Integrated Device Technology, Inc.
6024 Silver Creek Valley Road, San Jose, CA - 95138

PRODUCT/PROCESS CHANGE NOTICE (PCN)

PCN #: TB1912-02	DATE December 20, 2019	MEANS OF DISTINGUISHING CHANGED DEVICES:
Product Affected: 3mm X 3mm VFQFN		☐ Product Mark
4mm X 4mm VFQFN		☐ Back Mark
(Refer to attachment for affected part#)		☐ Date Code
Date Effective: March 20, 2020		☒ Other

ATTACHMENT I - PCN #: TB1912-02

Future Shipment in Cut Tape Packing for MSL 2/3/4 Product

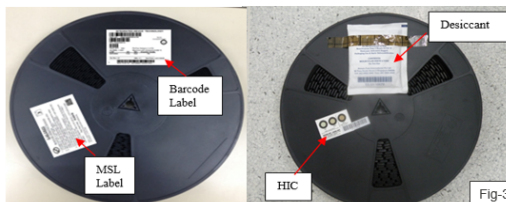
- Count and cut the parts in carrier tape as per order qty (Fig-1).
Note: Without Leader & Trailer empty pockets.
- Roll the part onto plastic reel and tape with conductive tape at both end (Fig-2 & 3).
**** Note :** Pass IDT Standard 6 fts drop test (Base on drop test result with NLG 16 (QFN 3x3 mm) and NLG 24 (QFN 4x4 mm))
- Pack with HIC & Desiccant
- Pack with MBB bag (Fig-4).
- Pack with pizza box (Fig-5&6).
- Over-pack the pizza box with Outer carton (Fig-7).
